Parks will be developing a parcel of land located at 936 16 Avenue S.W. into a vibrant public park space that can be well enjoyed and used by community members. The new 908 square metre park will help fill an open space void in a neighbourhood that is considerably deficient in park space.

New Park Space in the Beltline

Stakeholder Report Back: What We Heard, What We Did

December 2019

Concept 1

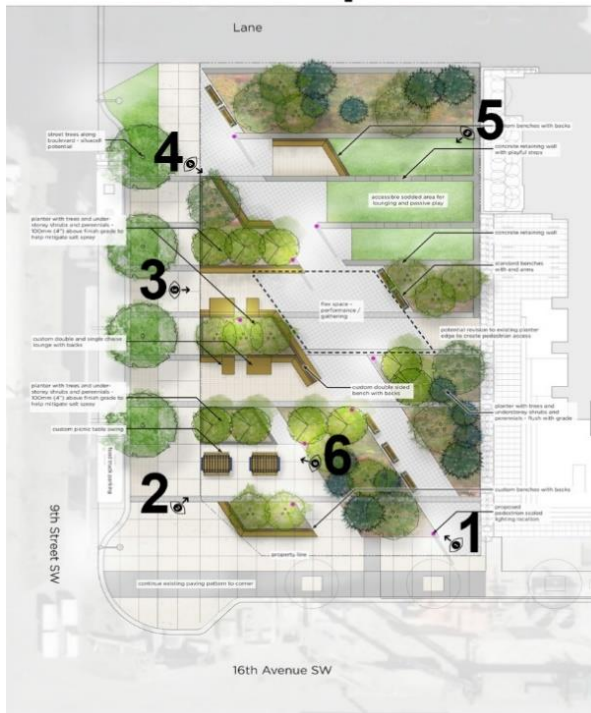
Concept #1	
Supportive Themes	Critical Themes
<p>Park layout The public generally liked the open layout and the hardscape walkway running SE/NW through the park.</p> <p>Clear sightlines into and out of the park space were a crucial component in this concept and was an idea that was supported heavily by the public.</p> <p>Seating options The public liked the variety of seating options, and the segmented nature of the design which allows for smaller gatherings.</p> <p>Softscape materials The public seemed to prefer a lush green space, with shade trees, understory plantings and colour.</p> <p>Accessibility & Safety The public were supportive of how universally accessible the site feels.</p> <p>Clear site lines through the park makes the park feel safe.</p> <p>Site Amenities The food truck idea is encouraged.</p>	<p>Seating options The public would like to see tables added to the design and ensure that the benches have arms to limit lounging.</p> <p>Consider seating that has an overhead cover.</p> <p>Playful elements The public thought that there weren't enough playful elements incorporated into the design.</p>

Park Elements	City Response
 <p>Softscape areas (types of grasses & plantings)</p>	<p>A variety of plant material has been incorporated into the preferred concept with a mixture of shade trees and understory plantings of all sizes. Manicured grass areas have also been dispersed throughout the park space with curving edges that act as a counter balance to the rectilinear geometry of the park’s urban surroundings. Tree placement has been specifically selected to ensure that sightlines into and out of the site are maintained to address safety concerns from the public.</p>
 <p>Hardscape areas (types of hard surfaces)</p>	<p>The hardscape pathway cutting through from the 16th Avenue S.W. edge of the site to the sidewalk along 9th Street S.W. was included in the preferred concept to help provide a safe and accessible walkway for pedestrian movement throughout the site. A mix of hardscape materials (permeable pavers and pavers) will be used on site to provide a variety of hard surfacing. The concrete ribbon curb has also helped to add a curvilinear feel throughout the park while allowing us to define segmented areas such as the flex space for performance and gathering.</p>

<p>Site furnishings (types of seating)</p>	<p>Simply put, a variety of seating options have been included throughout the park space to cater to individuals, as well as both small and large groups. Moveable seating will allow park users to adapt their sitting situation however they may feel which has proven to be successful in other parks in Calgary. The custom circular bench/entry element in Concept # 2 was a contentious item – both in its design and location. Some people felt that it created a welcoming gateway into the site; while others felt that it may harbour antisocial behaviour, create a barrier to the site, and be a potential safety hazard for children. The preferred concept incorporates the idea of a circular custom bench in a less enclosed way. The seating is now more open and facing the flex space, but still allows for intimate social gatherings with arm separations and an overhead structure. The design of the overhead structure will be cantilevered and louvered to lighten the feel of the structure.</p>

<p>Creative elements</p>	<p>The preferred concept maintains a lot of the original playful elements (swinging picnic table, ping pong table, circular seating/stage area), but organizes the space in a less compartmentalized way. The circular seating/stage area is now incorporated into a large curved seating area and is directly engaged in the flex space. The creative elements blend into the park space in an appropriate manner.</p>

Concept 2

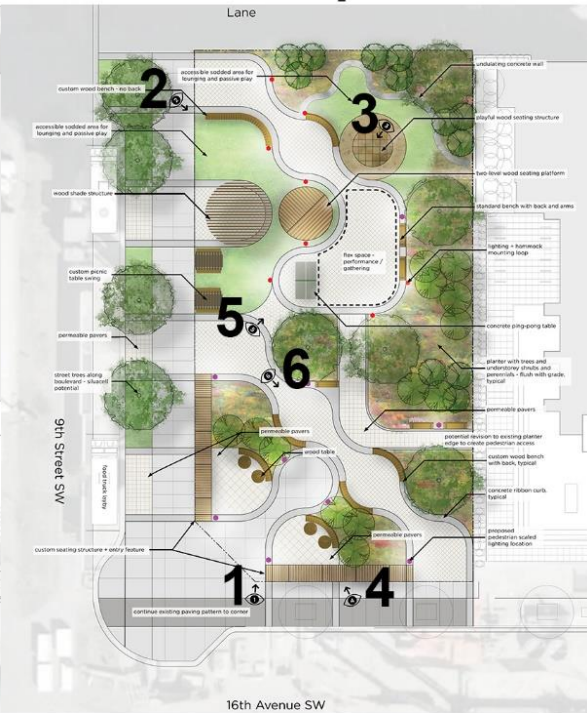
Concept #2	
Supportive Themes	Critical Themes
<p>Park layout The public enjoyed the organic and curved nature of the park layout. The curving aspects are a good counter balance to the geometry of downtown.</p> <p>Seating options The public seemed supportive of the variety of seating options</p> <p>Playful elements The public enjoyed the ping pong table and the hammock posts, the playful elements in the park were supported.</p> <p>Site Amenities The food truck idea is encouraged.</p>	<p>Park layout Too many different components that crowd the space.</p> <p>Softscape materials Park site needs more lush green space, with shade trees, and understory plantings.</p> <p>Playful elements The public liked the playful nature of the design but wanted to ensure that comfort was also considered in the design.</p> <p>Accessibility & Safety The public thought that the sightlines should be more open for safety reasons.</p>
